Technical Bulletin

No.: RB706001 Model: Model V-C1 Finisher (SR841) Date: 29-Mar-06

Subject: Stopper Vibrating Plate			Prepared by: H. Matsui		
From: 2nd Tech. Support Sec. Service Support Dept.					
Classification:	☐ Troubleshooting ☐ Mechanical ☐ Paper path ☐ Other ()	☑ Part informate☐ Electrical☐ Transmit/rec		☐ Action required ☐ Service manual revision ☐ Retrofit information

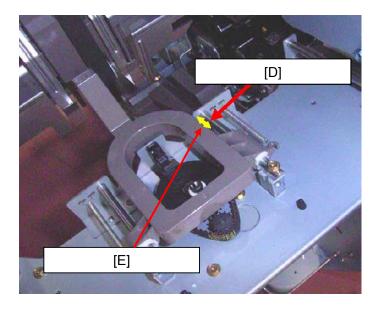
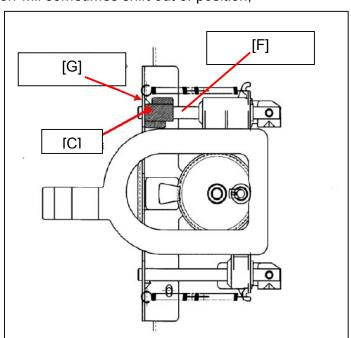
- 3. Peel the two-sided tape [B] off the new bracket [C].
- 4. Attach the new bracket to position [D].

- Make sure the new bracket [C] is flat against the edge of bracket [G].
- Make sure the new bracket [C] covers the shaft [F].

• The new bracket [C] limits the movement of the paper pressure unit [E]. This is to prevent the paper pressure unit from pressing curled paper too much. If curled paper is pressed too hard, the staple position will sometimes shift out of position,

20. FRAME SECTION 1 (B706)

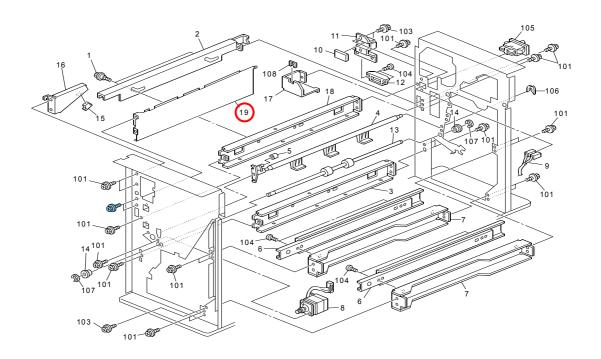
Change: This part was added.

Reason: To further protect the harness inside the machine from being touched.

Note: There is only a small possibility of the above case, so this part does not need to be

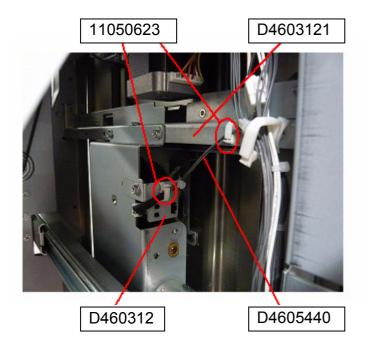
- 1) The shapes of the first three parts in the table were changed.
- 2) A harness clamp was added.

Reason: To facilitate a change in the layout (leading) of the harness, which further ensures that the harness connectors stay properly fixed in place.

20. FRAME SECTION 1 (B706)

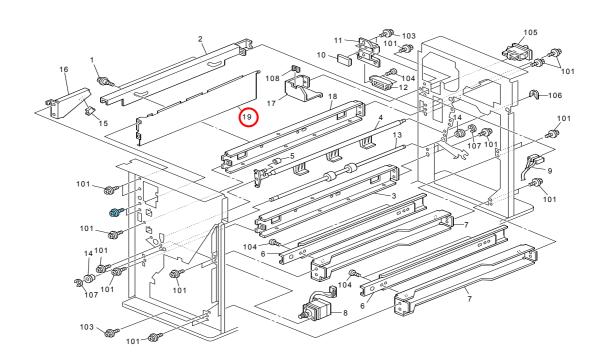
- 1) A cover for the door switch harness was added.
- 2) In accordance with this change, a screw hole was added to the safety switch cover and a tapping screw added.

Reason: To further protect the harness from physical contact.

Important: The newly-added door switch harness cover (D4601146) cannot be installed on machines produced before the cut-in serial numbers. On these machines, be careful not to touch the harness when you service the machines.
